Access Compliance Report

Public Rights-of-Way

Intersection ID: 21102	Main Street: S_TRYON_ST	Cross Street: WHITEHALL_PARK_DR	Location: S
ADA ID: 685BB9EC75D7	Ramp Type: Perp	Initial Pass/Fail: Pass	Overall Compliance: No
Severity Score: 0			
Codes/Mitigation Info/Possible Solution		Field Measurements/Component Compliance

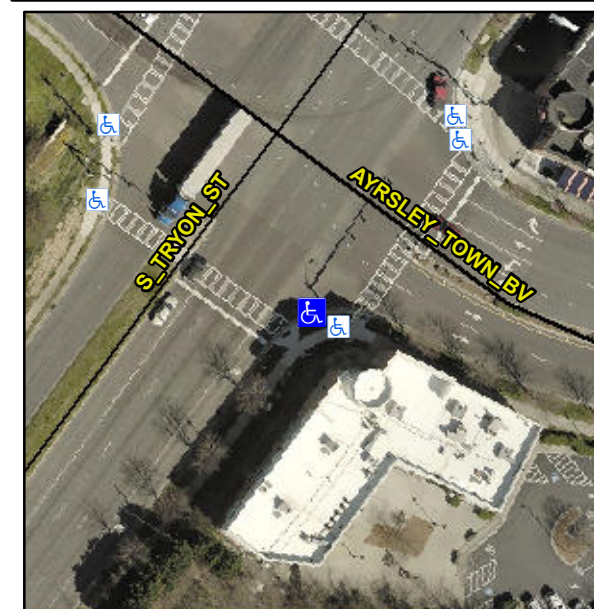
Remove & Replace Detectable Warning System.

R305.2
